42 HONEYSUCKLE DRIVE COTTAGE CREEK PRECINCT NEWCASTLE

NEWCASTLE CITY COUNCIL
DEVELOPMENT APPLICATION

ARCHITECTURAL DESIGN STATEMENT

SUMMARY OF PROPOSED AMENDMENTS

8.1 DESIGN CHANGES EIGHTH FLOOR

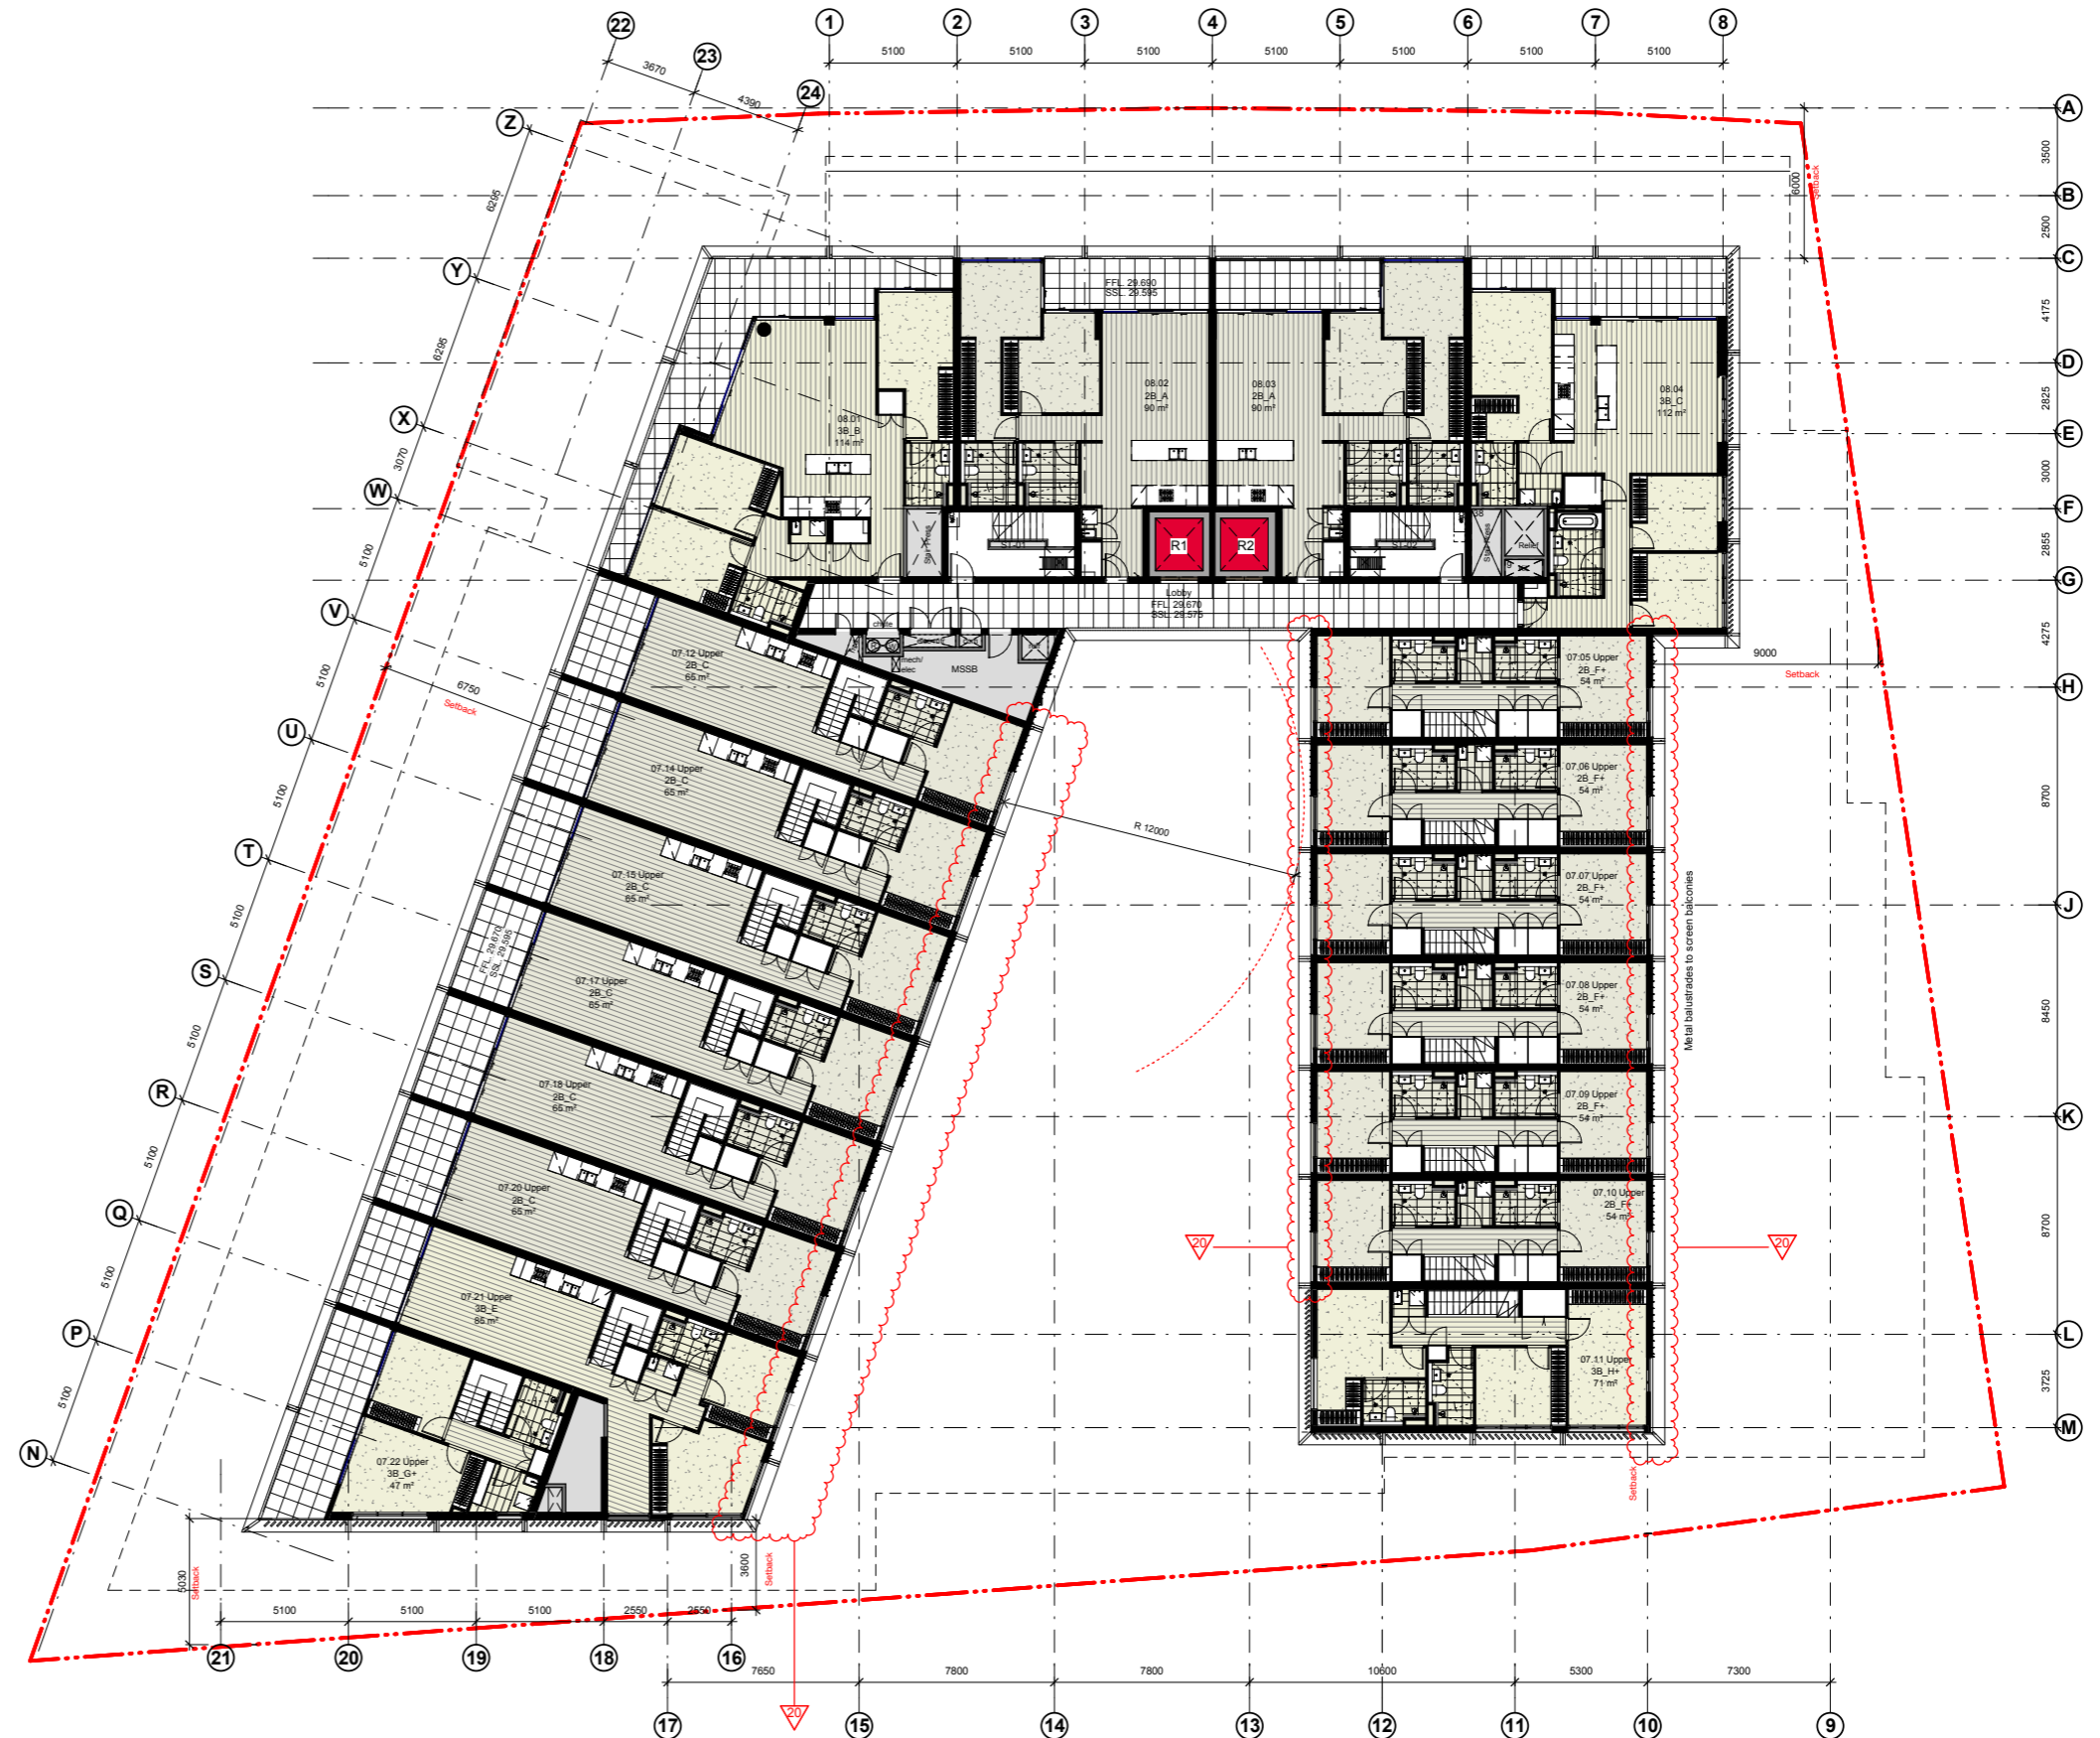
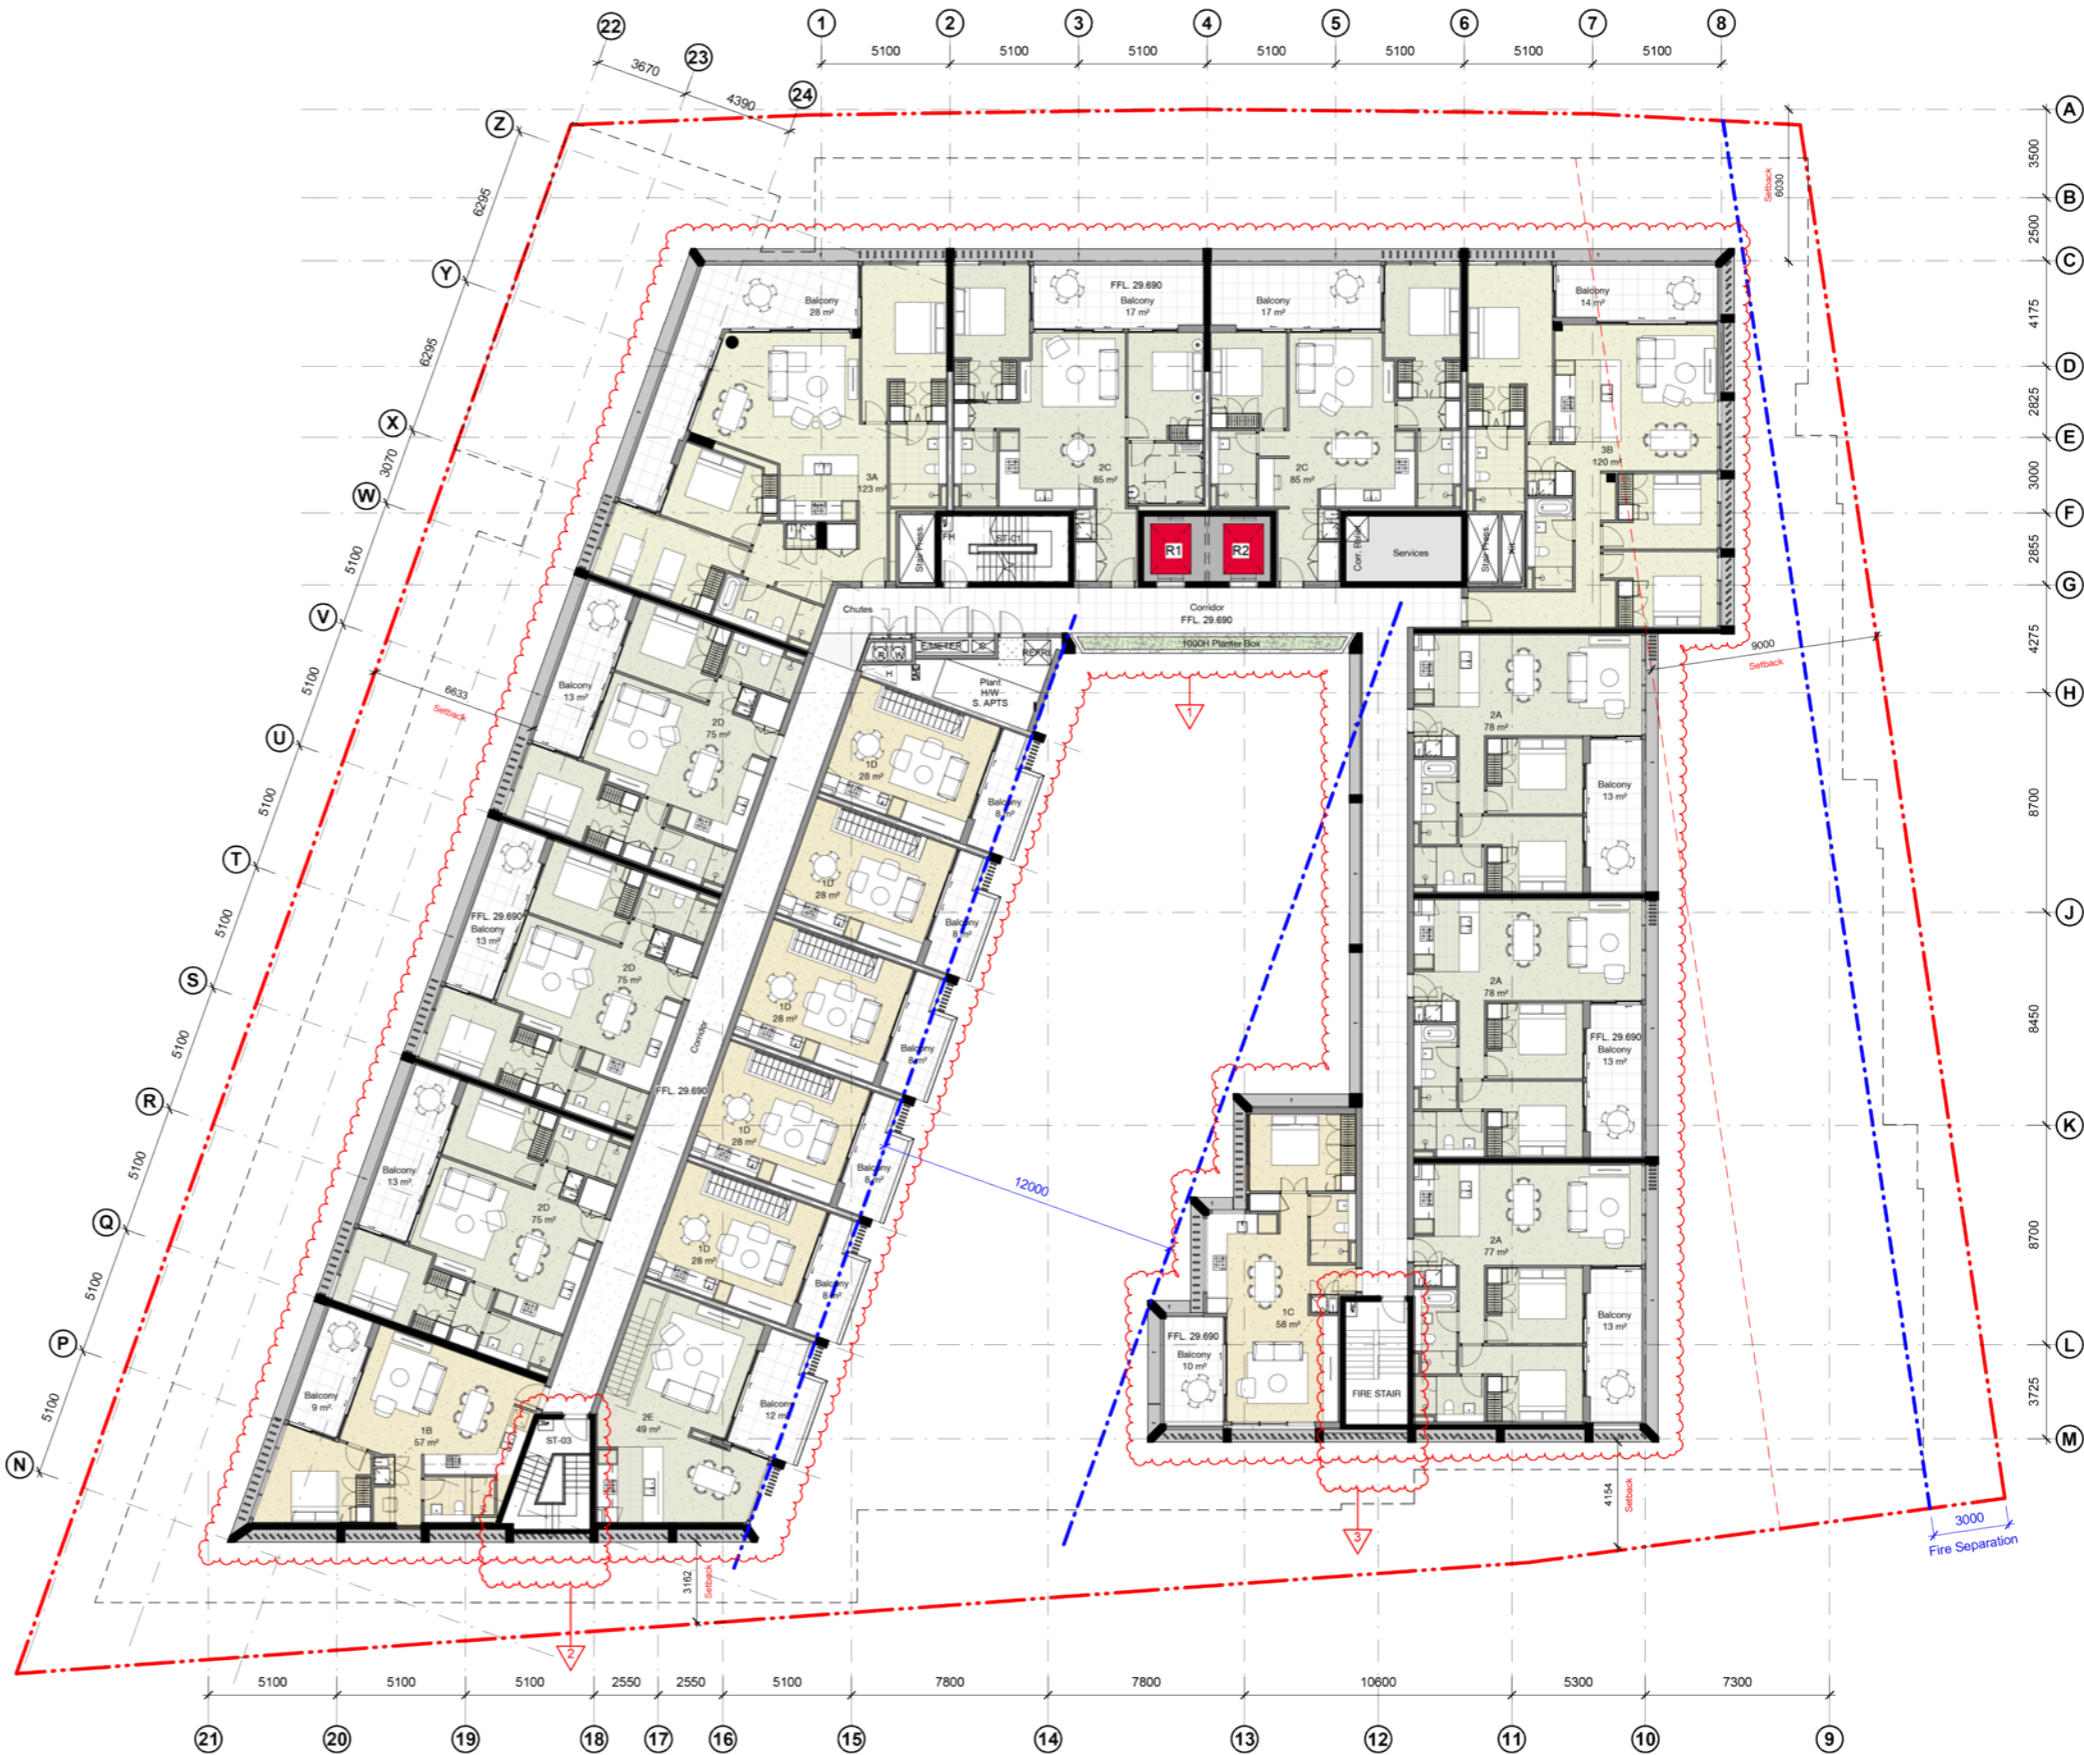
- 1 / Accommodation on Levels 05-08 amended from 52 residential apartments to 60 serviced apartments.
- Modifications to the south eastern building volume from Level 05 to 08 in response to the revised apartment typology
- Adjustments to the facade design from Level 05-08 in reponse to the revised apartment typologies. General materiality and facade components have been retained from the previously approved design.
- 2 / Adjustments to the location of the south western fire stair. To accommodate the revised serviced apartment floorplate, the fire stair shifts to the west by one hotel bay. Facade treatment from Ground to Level 04 are adjusted to suit.
- 3 / Adjustments to the location of the south eastern fire stair. To accommodate the revised serviced apartment floorplate, the fire stair shifts to the east. Facade treatment from Ground to Level 05 Parking are adjusted to suit.
